UNITED STATES DISTRICT COURT  
SOUTHERN DISTRICT OF NEW YORK

**NEW YORK SMSA LIMITED PARTNERSHIP  
d/b/a VERIZON WIRELESS, and HOMELAND  
TOWERS, LLC,**

**EXPERT REBUTTAL REPORT OF BONNIE FRANSON, AICP CEP, PP**

**Hudson River Valley National Heritage Area Map,  
prepared by Saratoga Associates.**

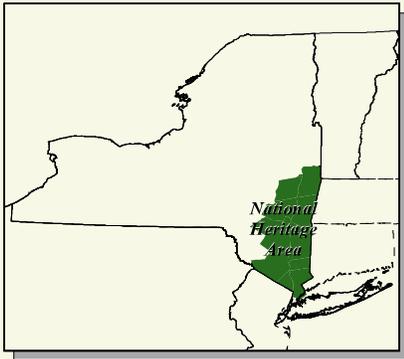
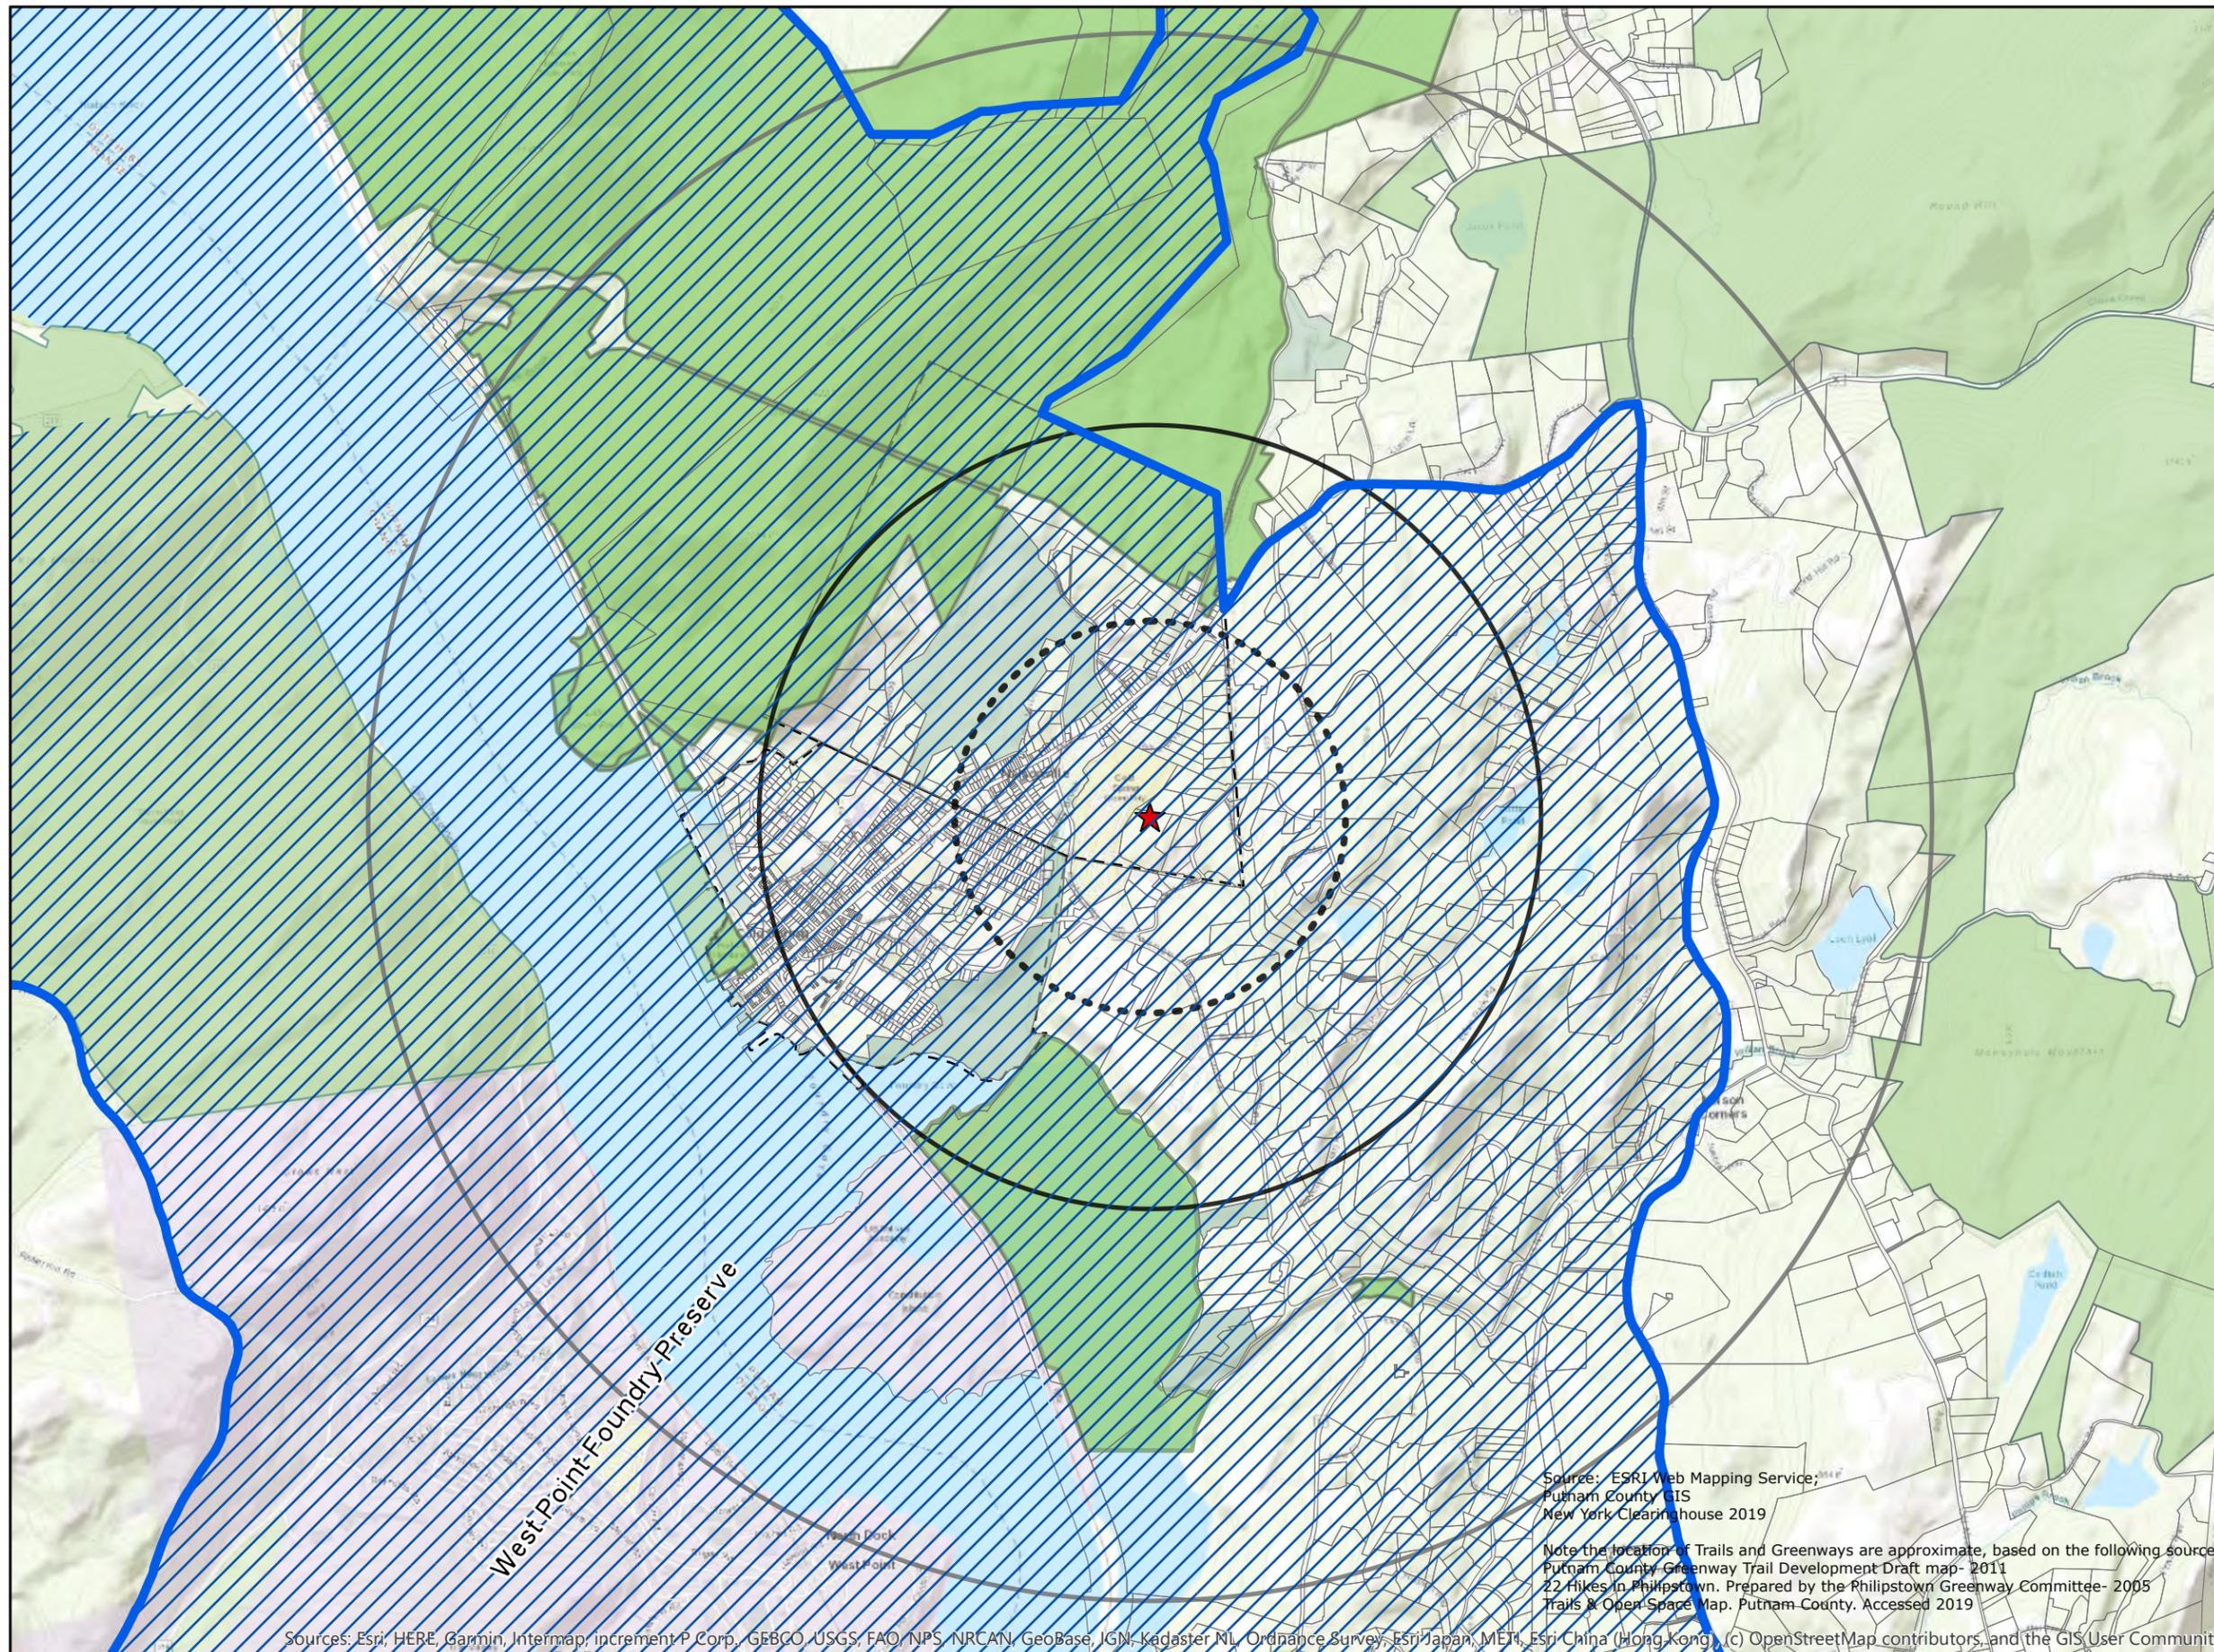
36. The ZBA was provided with various Visual Resource Assessments prepared by Saratoga Associates and documented in the Allen affidavit at paragraph 6. The Visual Resource Assessments are flawed in that they do not comply with various visual impact policies promulgated by New York State agencies including the DEC Policy and do not comply with the guidelines contained in the New York State Department of State (“DOS”) “Planning and Design Manual for the Review of Applications for Wireless Telecommunications Facilities - A Practical Guide for Communities Managing Wireless Telecommunications Facilities Siting in New York State” (“DOS Manual”). The June VRA and its supplements do not provide any narrative context describing the significant historic and scenic landscape within which the tower is proposed. The Visual Resource Assessments fail to disclose that the proposed tower is located within the federally-designated Maurice D. Hinchey Hudson River Valley National Heritage Area which is managed in partnership with the U.S. National Park Service. The Hudson River Valley National Heritage Area was designated by Congress in 1996 and is one of only<sup>7</sup> fifty-five federally-recognized National Heritage Areas throughout the United States. Ironically, the Hudson River National Heritage Management Plan includes a map identifying the area on a map prepared by Saratoga Associates (**Exhibit W**).
